Subject: Service Bulletin 159-020-00, Rev. 0
for Onboard Systems Bell 206L / 407 Cargo Hook Suspension System

SERVICE BULLETIN

Document No. 159-020-00 Rev. 0

Subject: Bell 206L/407 Cargo Hook Suspension System failure.

Figure 2. Adverse condition

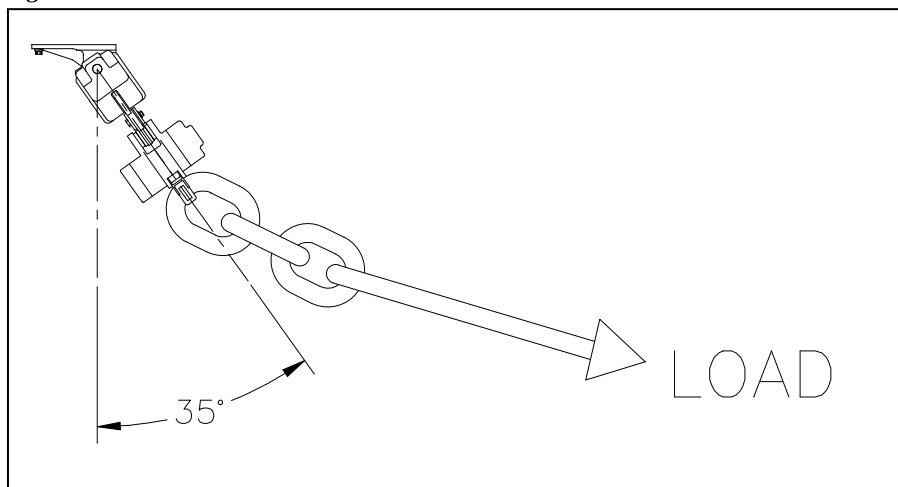
Cause: Investigation has shown that failure of the Load Cell resulted from excessive bending stresses.

In the typical operational mode of the Cargo Suspension System, the Load Cell is not subject to bending. The Cargo Suspension system is designed to accommodate loads through an angle of up to 35°—both forward and aft. However, when loads exceed 35°, the travel stops on the Pillow Blocks prevent the Suspension Beam from further rotation and cause bending stresses to be carried by the Load Cell.

The situation is most likely to occur when flying at high speed with light loads which have large aerodynamic drag. For example, an empty fire or fertilizer bucket or an empty long line. Figure 2 illustrates the adverse loading situation.

Figure 3. Old & new travel stops

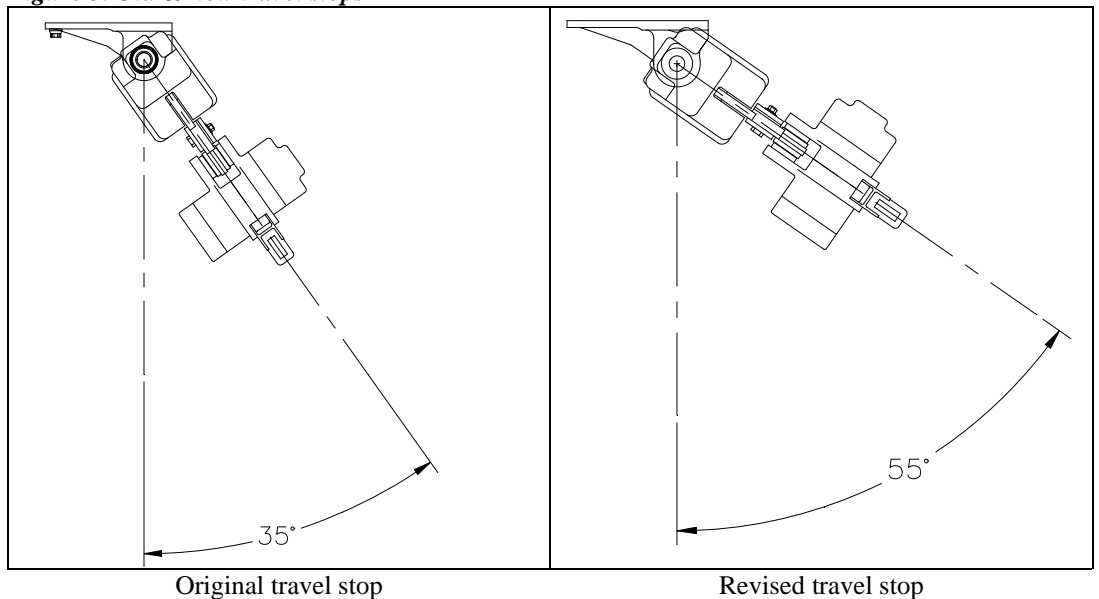
Solution: Onboard Systems has redesigned the Pillow Block to allow trailing angles up to 55°. See Figure 3. This design minimizes the possibility of placing bending stresses on the Load Cell or Carriage by allowing for large trailing angles.

Figure 4. Identification of updated Pillow Block

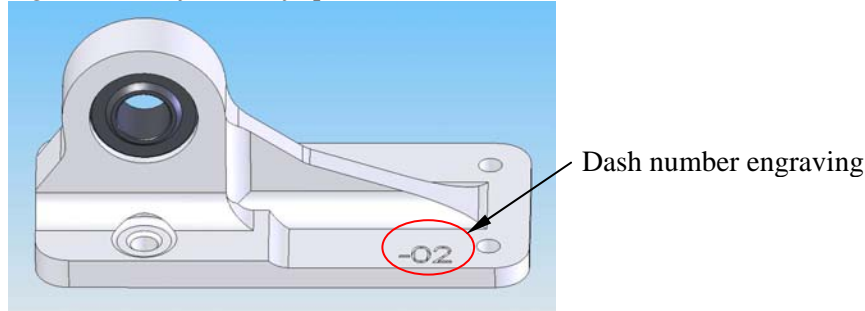
Action: The user should replace the existing Pillow Blocks (232-030-01) with the new Pillow Blocks (232-030-02). The new Pillow Block can be identified by the “-02” marking on the surface. See Figure 4.

1. Visually inspect the Pillow Blocks to see if the new Pillow Blocks have already been installed. If the Pillow Block has a “-02” marking on it then no further action is required. If the Pillow Block is not marked, then proceed to the next step.
2. Disassemble the Beam and remove the Load Cell Assembly (210-179-00).
3. The next step requires an assessment of damage to the Load Cell. However, the cover plates may hide damaged areas on the Load Cell. As the Load Cell is not field-serviceable, it must be returned to the factory for a one-time inspection.
4. Remove the old Pillow Blocks (232-030-01) and replace with the new Pillow Blocks (232-030-02). Refer to the appropriate Onboard Systems Owners Manual for instructions on how to install the Pillow Blocks. See the list of affected publications.

1. Visually inspect the Pillow Blocks to see if the new Pillow Block has been installed. If the Pillow Block has a “-02” marking on it then no further action needs to be taken. If the Pillow Block is not marked then perform the following tasks.
2. Disassemble the beam to remove the carriage (290-369-00).
3. Visually inspect the carriage to verify that it is free of cracks, excessive wear or other damage. If questionable damage is found, return the part to Onboard Systems for evaluation or replacement.
4. Remove the old Pillow Blocks (232-030-01) and replace with the new Pillow Blocks (232-030-02). Refer to the appropriate Onboard Systems Owners Manual for instructions on how to install the Pillow Blocks. See the list of affected publications.
